ZIGGY'S COFFEE STAND  
MODIFICATIONS TO DRIVE UP

SITE PLAN

**C-4**

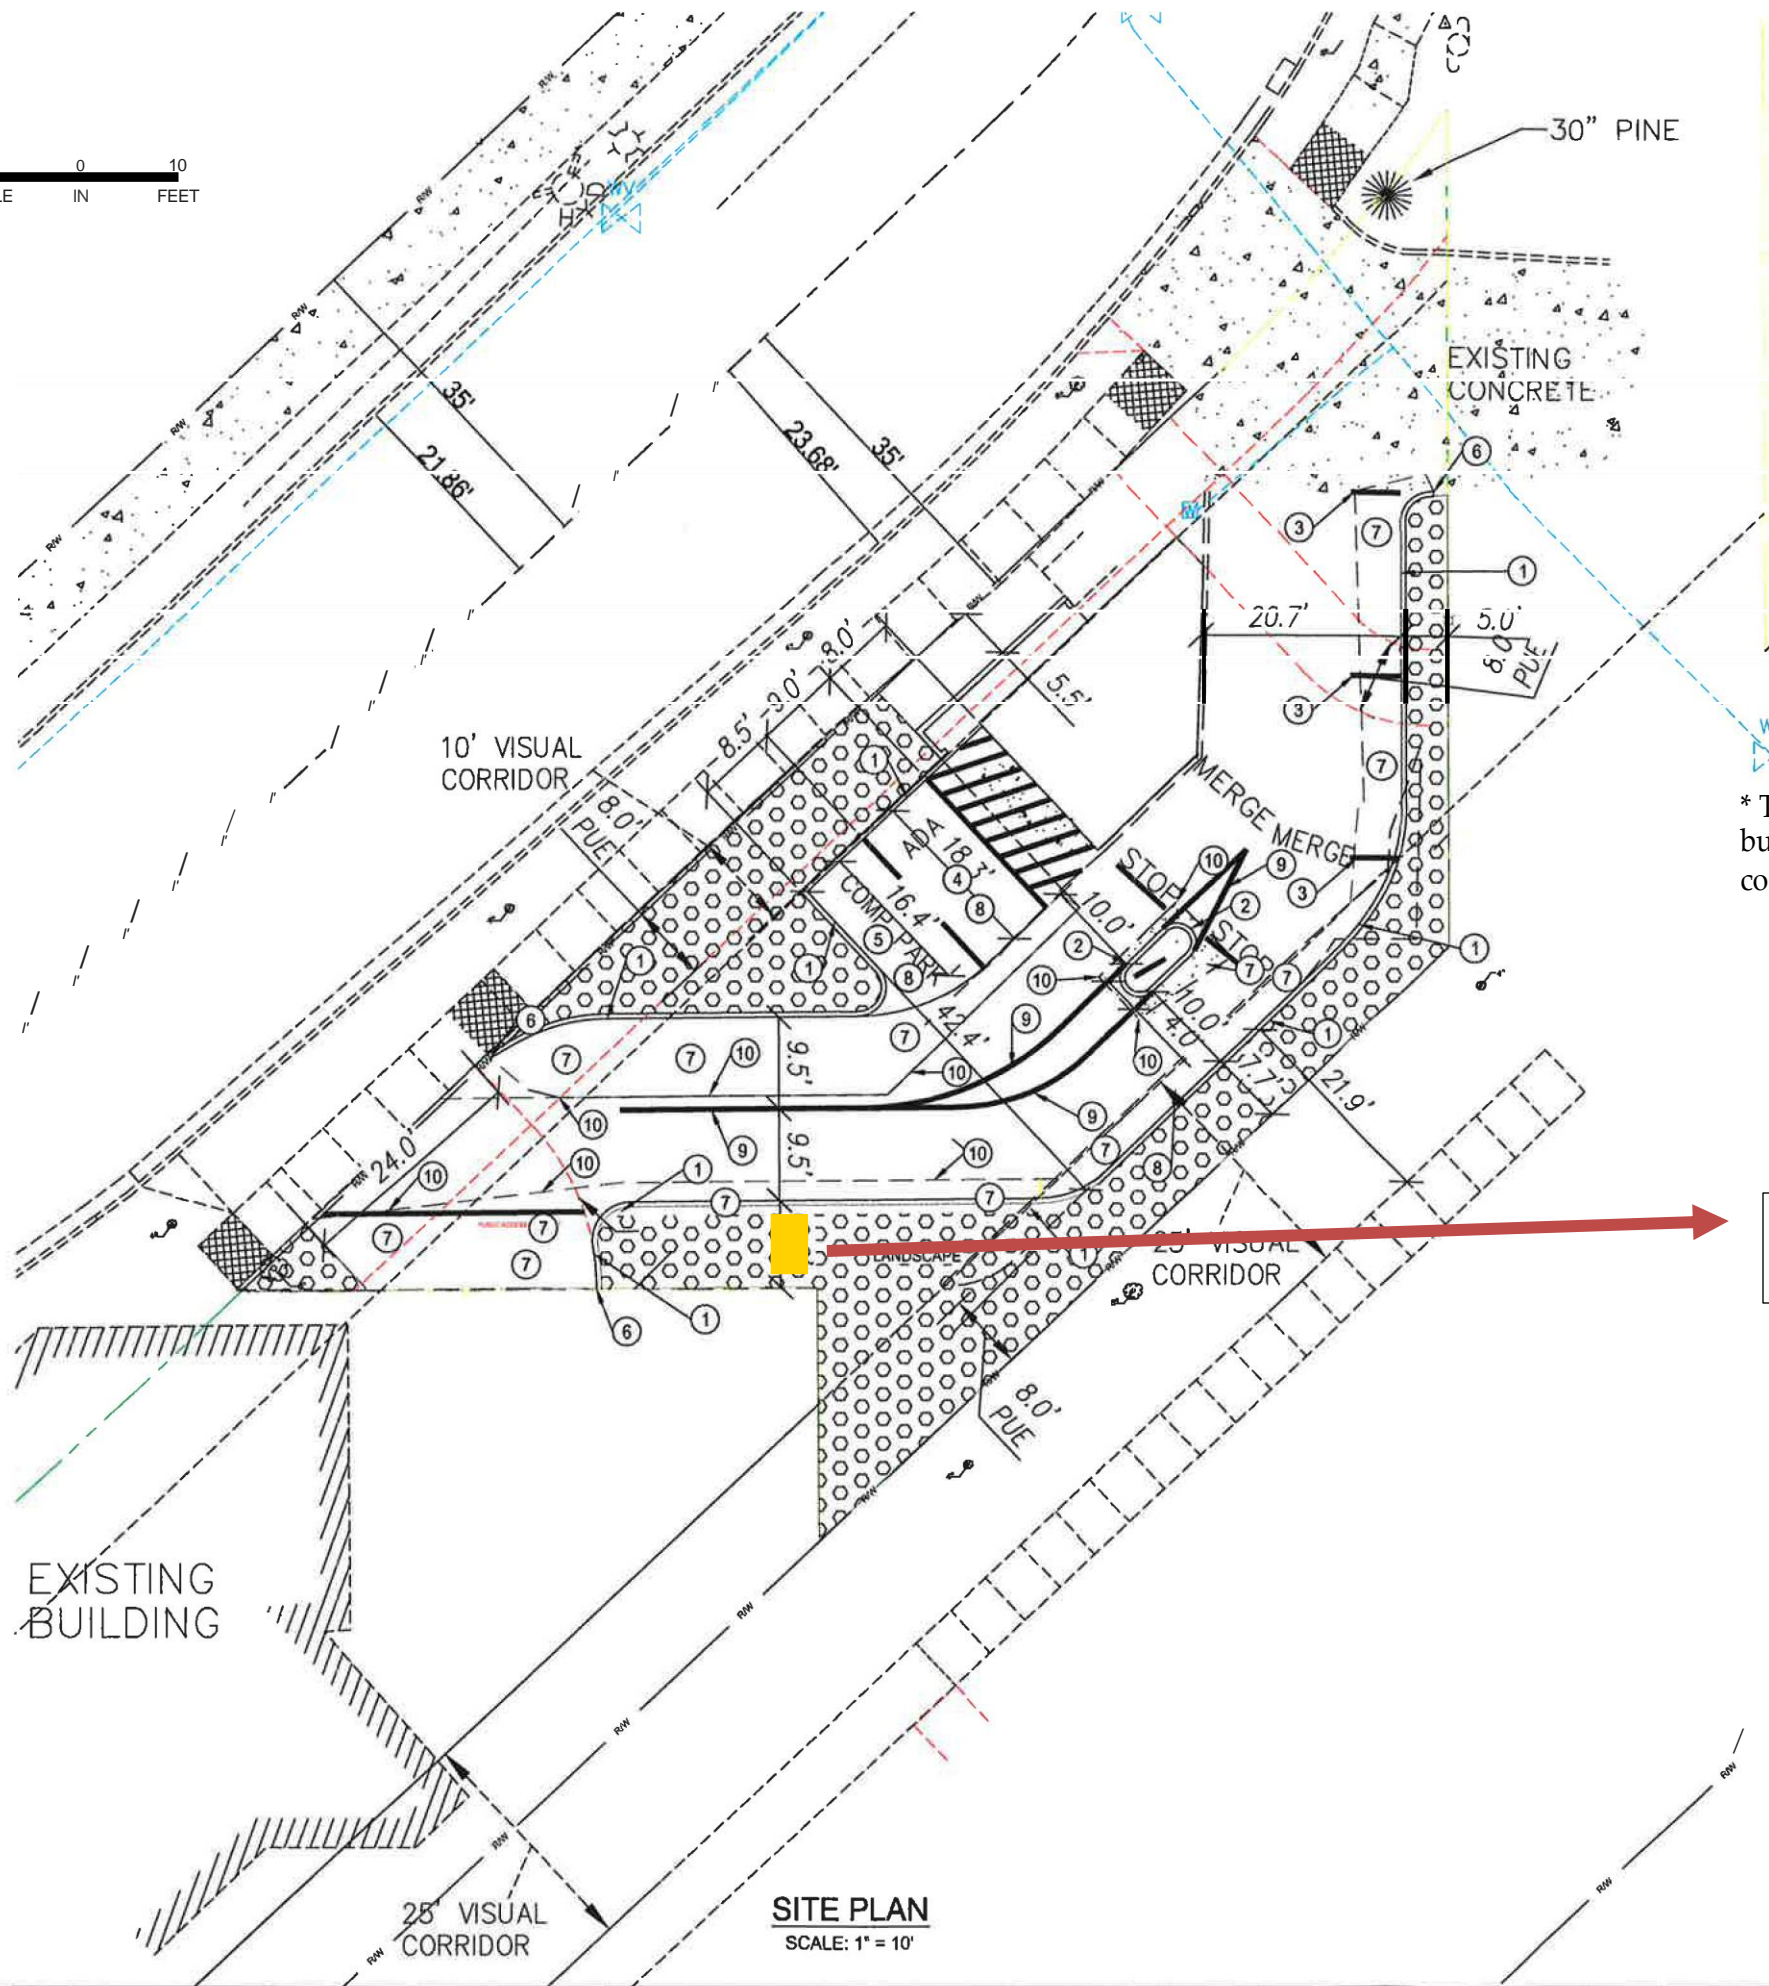
\* The yellow highlight indicates the Class B Variance request. A 10 ft. landscape buffer is required, the applicant is proposing 9 ft, which is a 10% reduction of the code standard.

The width of this area is 9 feet and not the required 10 ft per code. This 1 ft reduction is a Class B Variance.
